Addendum 3

Project Stadium New Press Box – Marlin ISD

Issued February 1st, 2024 by CEI Engineering Associates, Inc.

Item 1 – Press Box Electrical Scope Clarification

E6.01

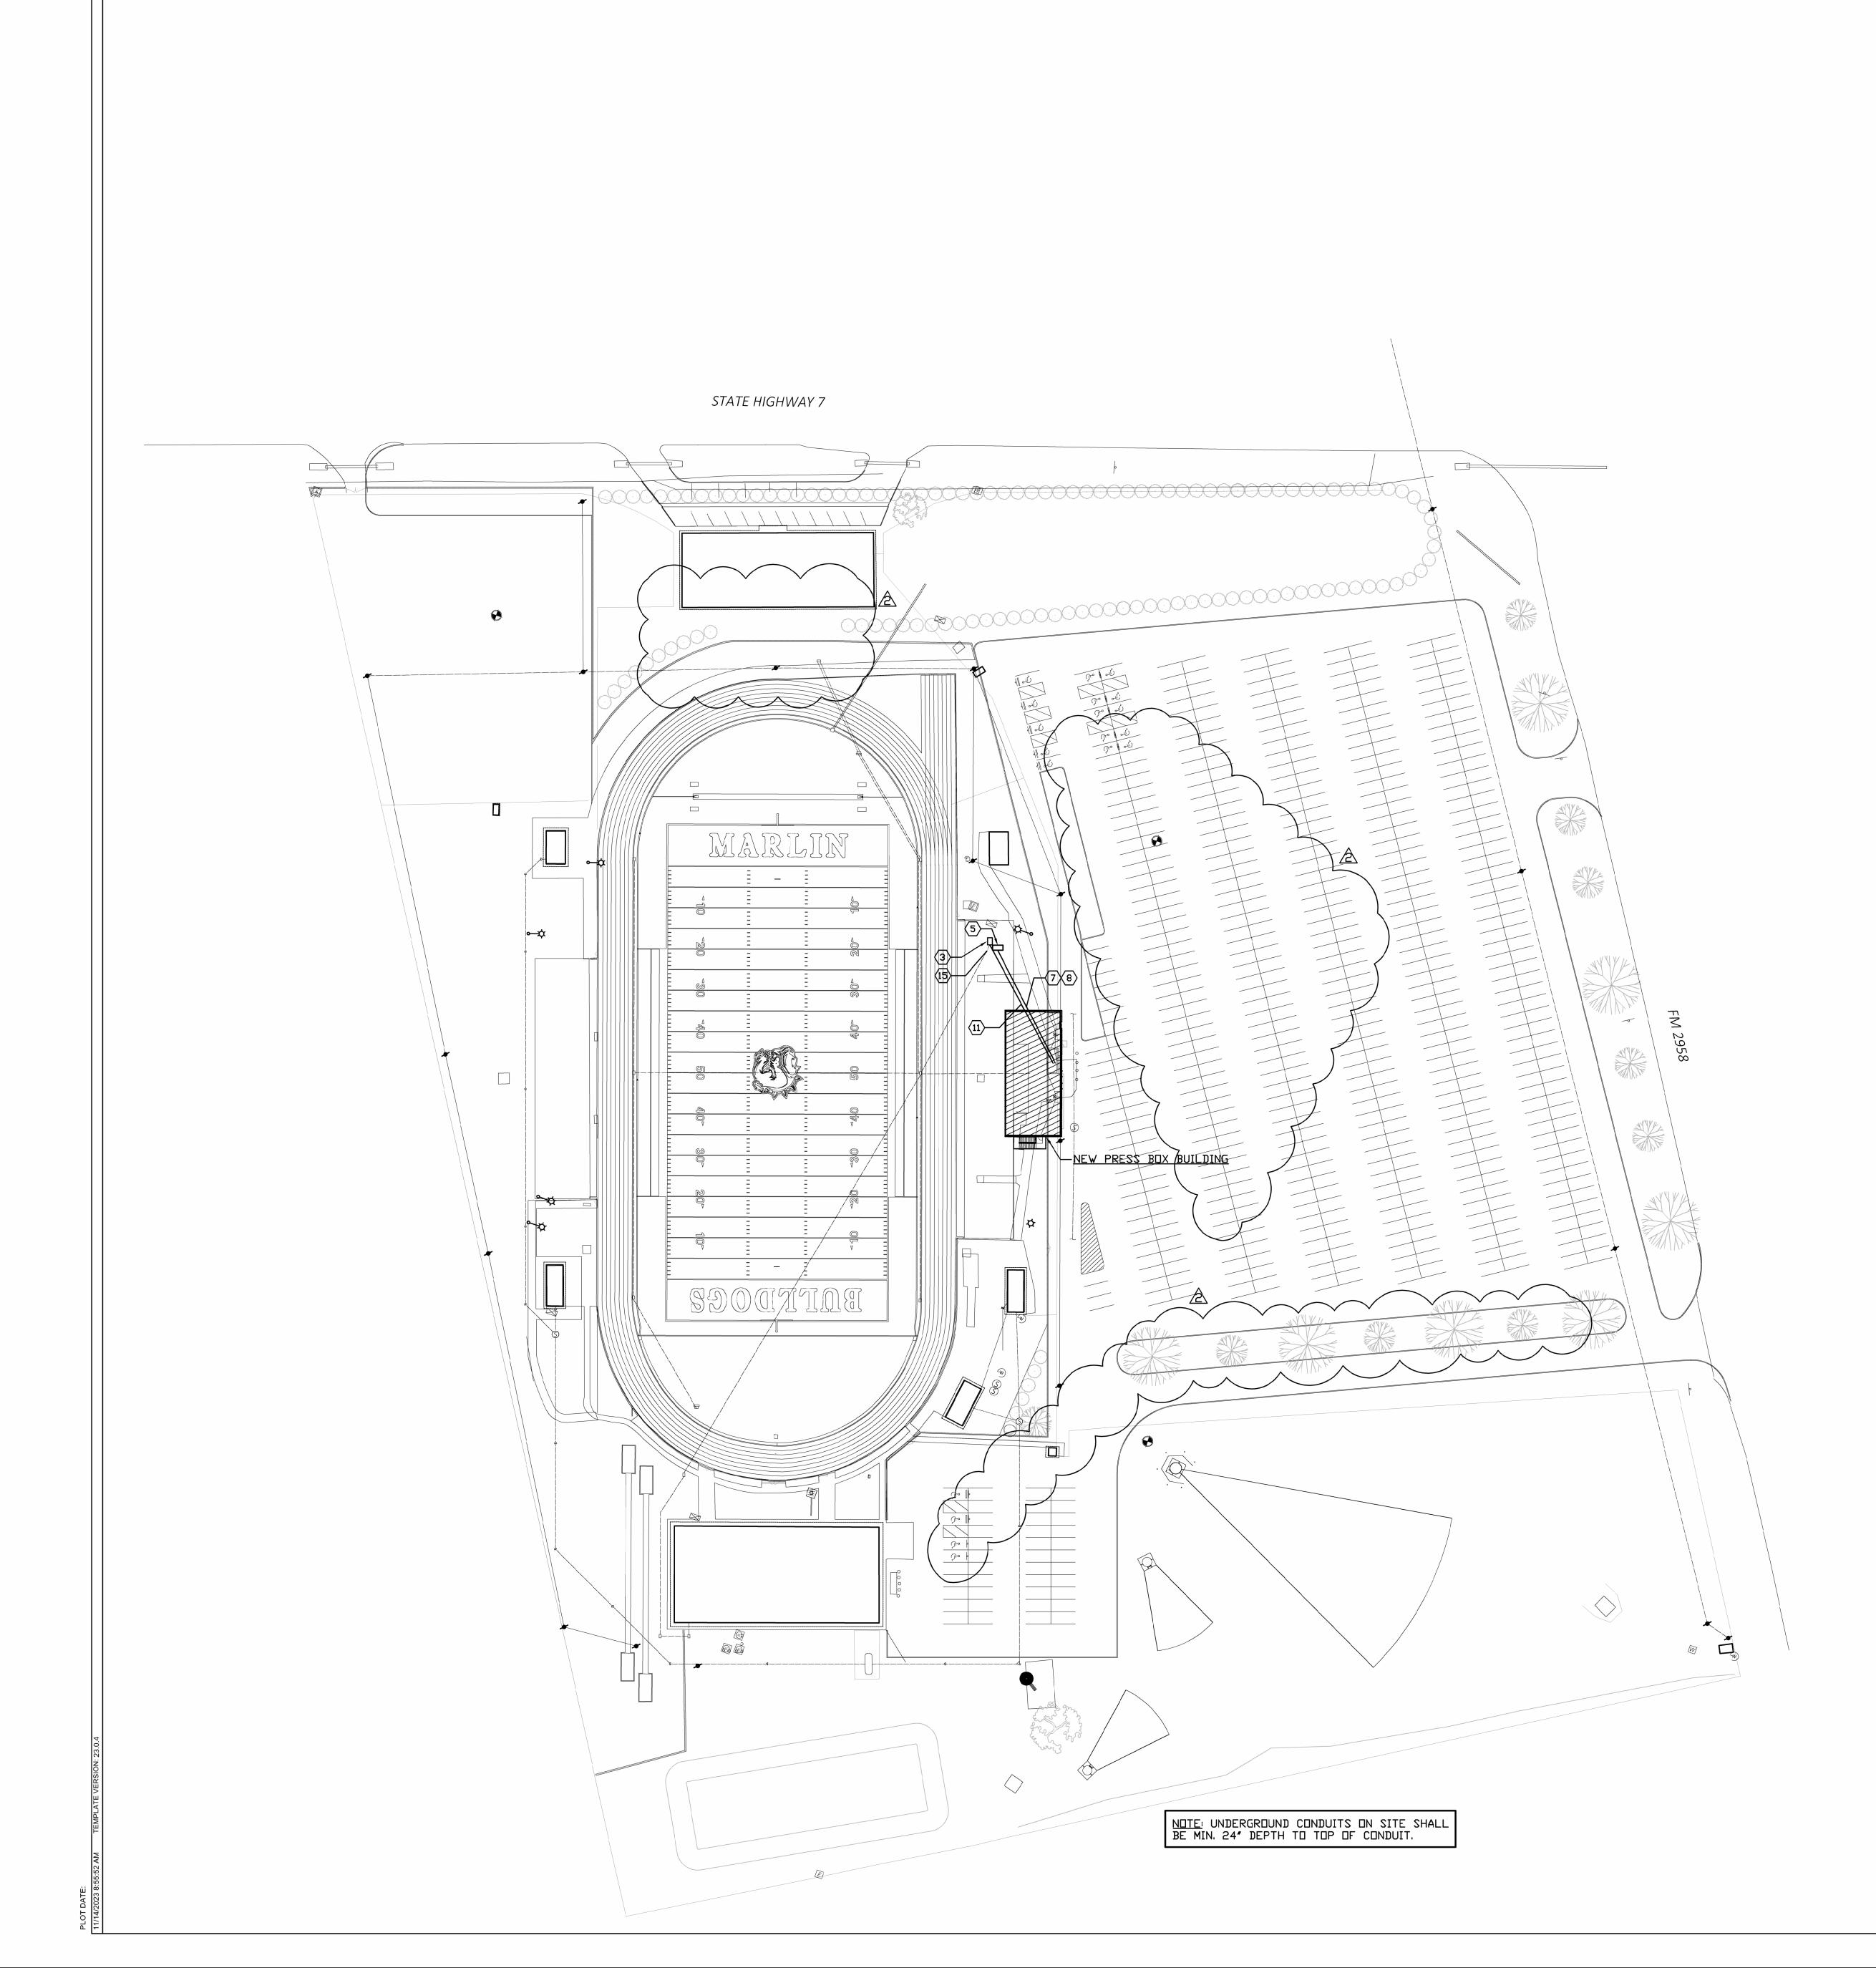
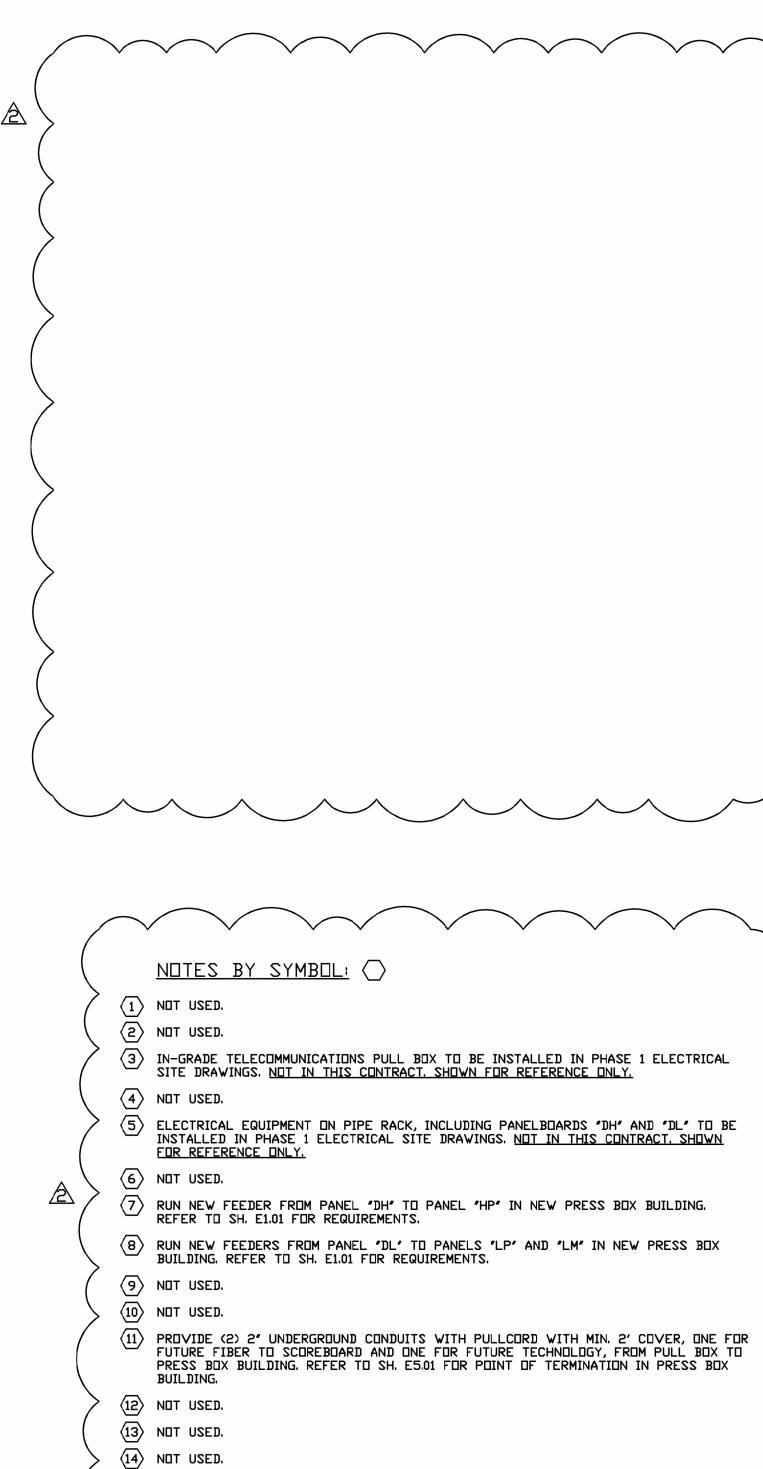
1. Sheet E6.01 – Electrical Site Plan has had its notes revised to clearly indicate the scope of this project.

Changes include clarification regarding what portions of the work at the stadium are to be included as part of this proposal and which are to be performed by others.

2. For clarification purposes, the scope of this project does not include any work in the parking lot area show on the stadium site plan. That work will be preformed by others. Also, the new scoreboard will be provided and installed by others.
